UNITED STATES DEPARTMENT OF COMMERCE
Patent and Trademark Office

APPLICATION NO.	FILING DATE	FIRST NAMED INVENTOR	ATTORNEY DOCKET NO.
09/214,519	01/07/99	HASHIZUME	T 101850

Office Action Summary

Response to Amendment

FIG. 5

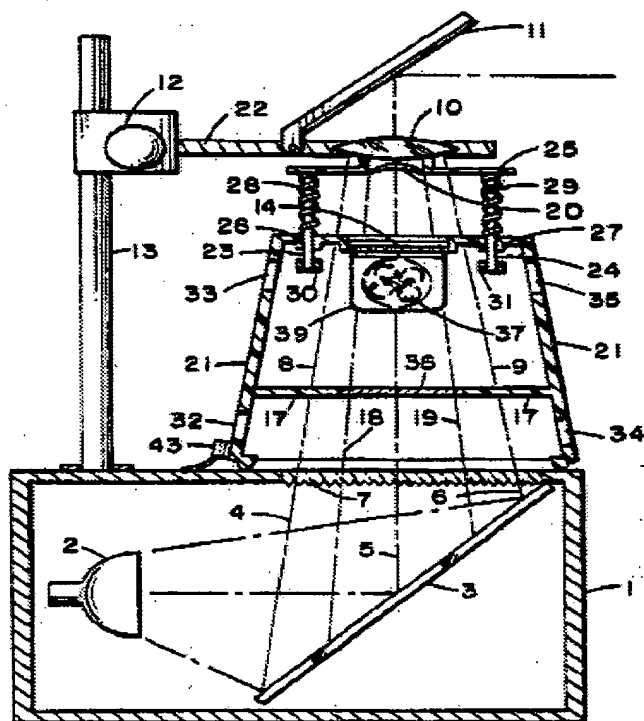
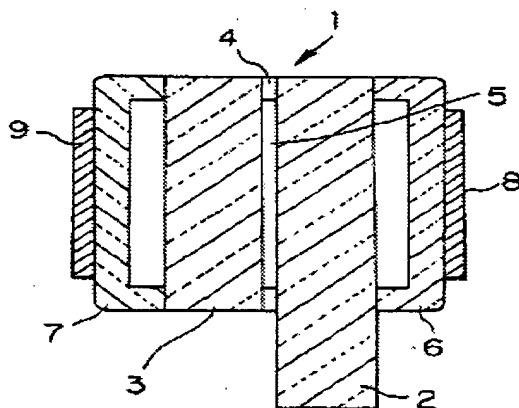
Regarding claims 1 and 4 (amended), Yamada et al. disclosean optical modulation element[Fig 5, #5] a transparent plate [Fig 5, #3] secured to the optical modulator a projection unit [Fig.2, #209].

Regarding claims 2 and 9 (amended), Yamada et al. disclosea polarizer [Fig 5, #9] bonded to the transparent plate.

Regarding claim 6 (amended), Yamada et al. disclose the transparent plate [Fig 5, #3] thickness is larger than the focal length of the projection lens [Fig 2, #209].

Regarding claim 8 (amended), as best the examiner is able to ascertain, Yamada et al disclose a polarizer [Fig 5, #9] and a pair of substrates [Fig 5, #2 and #3]
